DEPARTMENT FOR COMMUNITY SUSTAINABILITY
Planning Zoning Historic Preservation Division
1900 2ND Avenue North
Lake Worth Beach, FL 33461
561-586-1687

DATE: April 28, 2021
TO: Members of the Planning and Zoning Board
FROM: Alexis Rosenberg, Senior Community Planner
THRU: William Waters, AIA, NCARB, LEED, AP BD+C, ID, SEED, Director for Community Sustainability
MEETING: May 5, 2021

SUBJECT: **PZB Project Number 21-01400002:** A request by WGI, an engineering and land development firm, on behalf of MA Investment Boca, LLC for consideration of a Residential Urban Planned Development, Development of Significant Impact, Major Site Plan, Conditional Use Permit, Transfer of Development Rights, and Sustainable Bonus Incentive Program to allow the construction of 200-unit multi-family development at 3300 Boutwell Road, within the Mixed Use – West (MU-W) zoning district. The subject properties PCN is 38-43-44-20-01-034-0040.

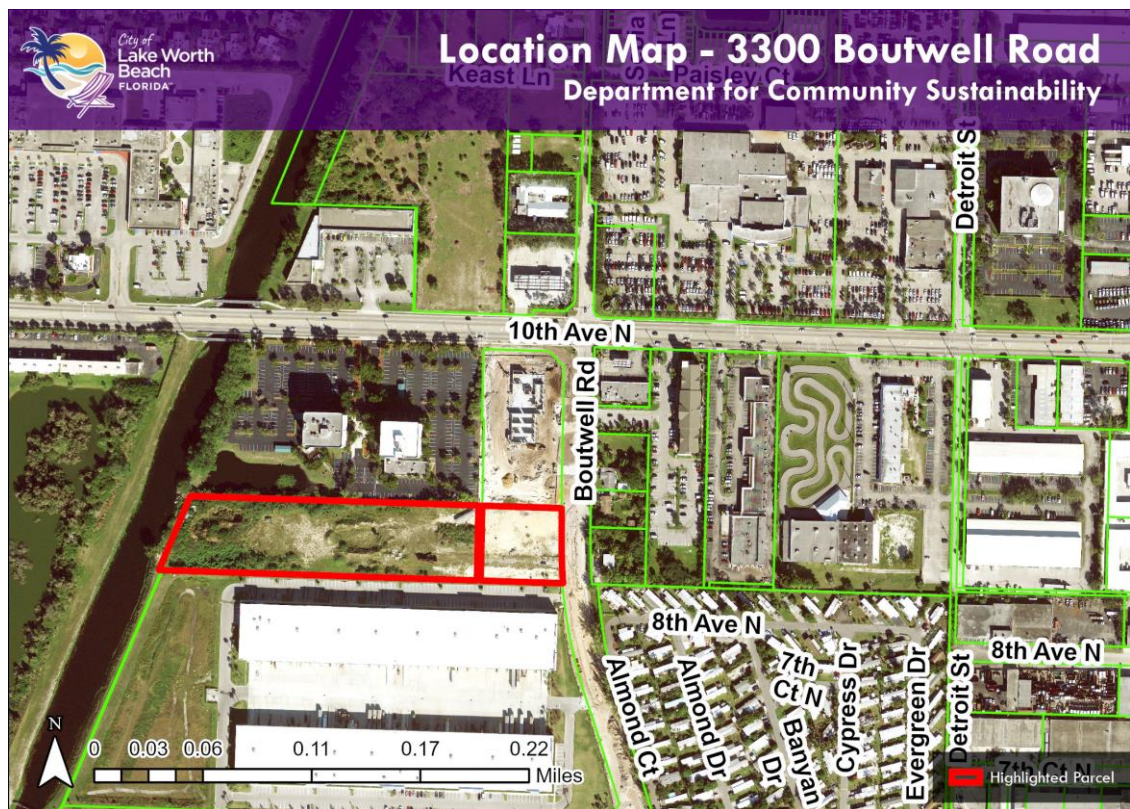
The subject site is a vacant 4.746 acre parcel located in the southwest corner of Boutwell Road and 10th Avenue North. On September 7, 2016, the Planning and Zoning Board approved a 199,135 square foot, six story, 158 apartment complex at the subject site. The apartment complex was approved in conjunction with a five story, 100 room hotel to the north at 2224 10th Avenue North (PZB 15-01400003 and 15-00500009). The new proposed development, also referred to as Boutwell Road Apartments, consists of two residential buildings including a clubhouse/mailroom. The project proposes a total of 200 multi-family units. Of the 200 units, 120 units will be one-bedroom units, and 80 units will be two-bedroom units. There are 293 parking spaces provided on site with a portion of the parking side-loaded to Building B and the remaining parking spaces located interior to the site. Of the 293 parking spaces, 226 spaces will be standard spaces, 41 spaces will be compact spaces, and 26 spaces will be provided in the form of bicycle racks. Additionally, the development proposes electric vehicle charging stations, as required by code, that will service 13 spaces.
